## Response to Reviewer #2

### General comments

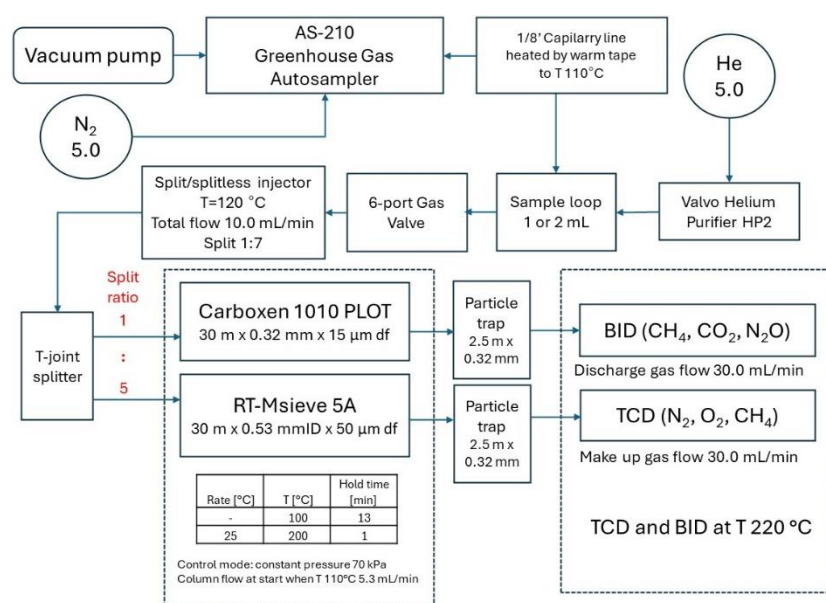
*L78. It is not clear what “and/or” means. In a certain case, both the two-column system and the single-column system are required?*

You have right, this is misleading phrase. We will delete “and/or” and leave only word “or”.

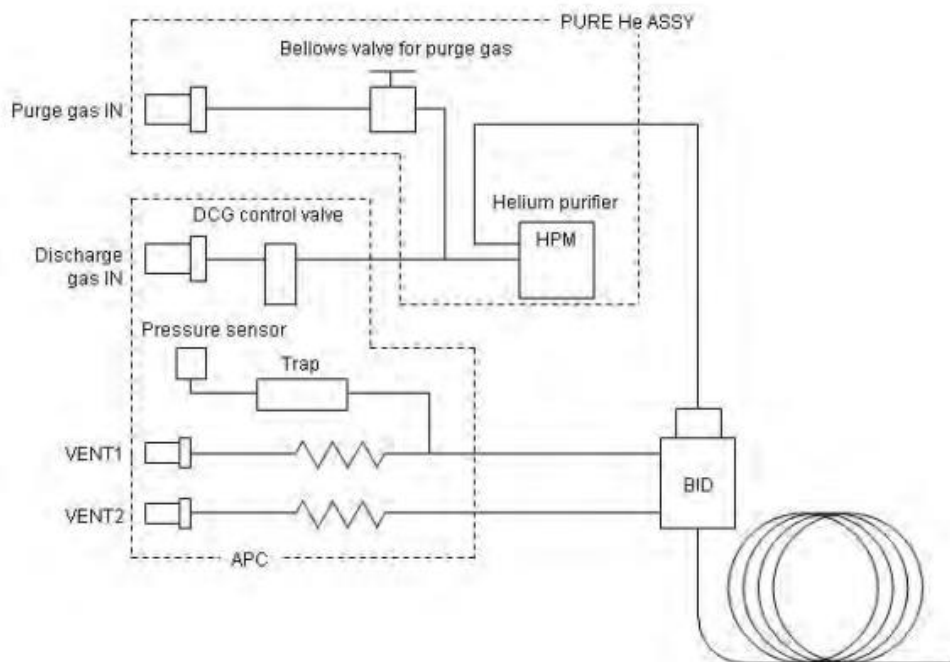
L107-110. I guess the length and inner diameter of the columns are described here, but the splitting ratio of 1:5 cannot be achieved with the dimensions shown here. Add other parameters such as thickness of the inner coating of the columns. Also, combination of column and detector should be clearly described or shown using a figure. Is the TCD connected to the molecular sieve column?

We will modify the description in the text as well showed basic information on GC scheme. The corrected text will be as below:

Additionally, using a t-joint, the injection sample was then divided between two porous layer open tubular capillary columns filled molecular sieve 5A (RT-MSieve 5A 30 m x 0.32 mm x 50  $\mu\text{m}$ , Restek, USA, #18284) and fused silica (Carboxen 1010 PLOT 30 m x 0.53 mm x 0.15  $\mu\text{m}$ , Supleco, USA, #24246). The dimensions of the columns were selected to achieve a splitting ratio of 1:5, directing most of the sample to the Carboxen 1010 PLOT and BID. Corresponding calculations were performed in Shimadzu AFT (Advanced Flow Technology) software.

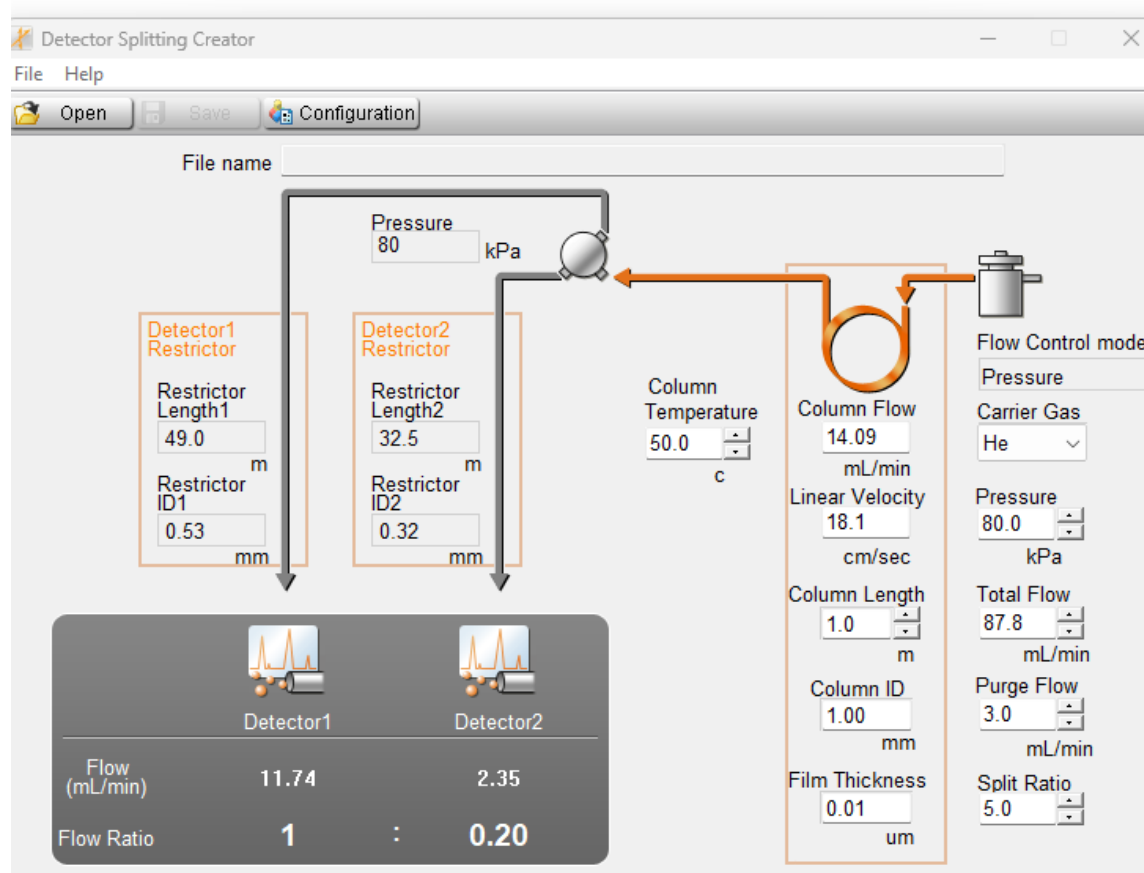
L115-117. It is not clear at which position the discharge gas is added to the flow system.

Discharge gas is connected and passed from the top, it is used to create plasma, below is a technical scheme from Shimadzu manual instruction:

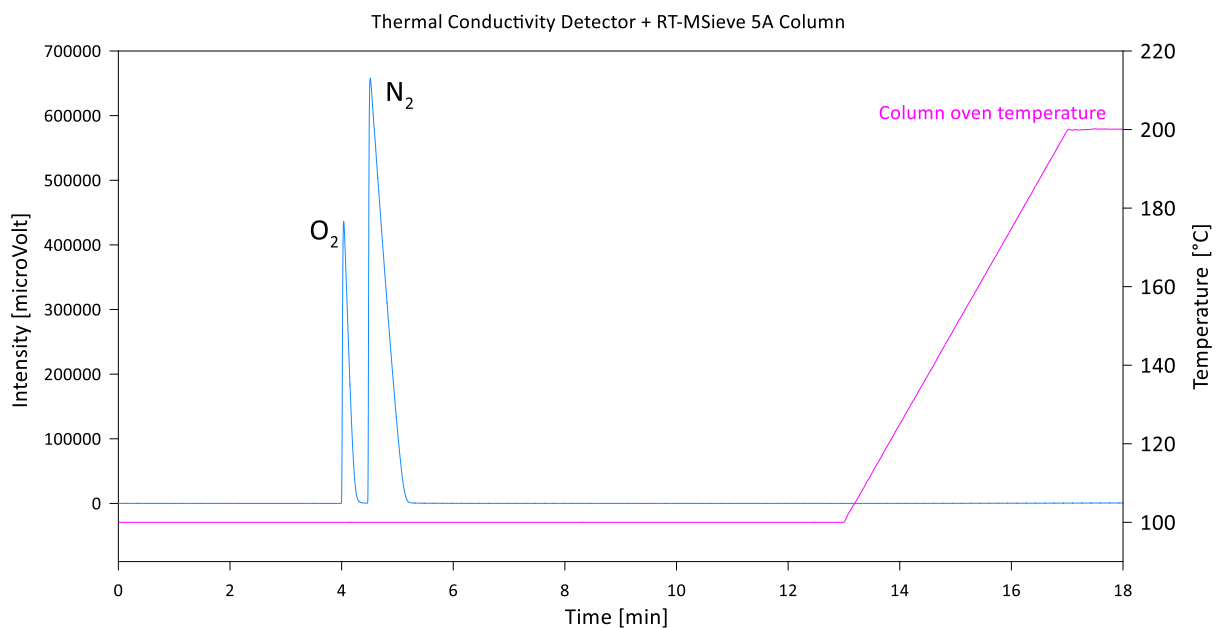
*L235–237. I cannot understand these sentences. Do the authors mean the “GC” results of CO<sub>2</sub> obtained after 25/11/23 18:00 (Figure 3) have a systematic error due to a shift in sensitivity of the detector?*

Yes, some shift occurred, eg. due to change in air moisture, this was Friday evening after all people left laboratory. But importantly, with new calibration the both measurements would stay in very good agreement.

One of the reason why Picarro is much more precise could be amount of sample analysed. Picarro analyses at least 20mL of sample for constant measurement, which make a single measurement every few seconds. Our GC system is sampling air in the volume of 1 or 2 mL. By design, such a measurement will not be as accurate in the long-term run as a device specifically dedicated to analyzing CO<sub>2</sub> or N<sub>2</sub>O fluctuations in the atmosphere. Our system is not limited to low concentrations of GHG's, which is why it stands out from other special devices.
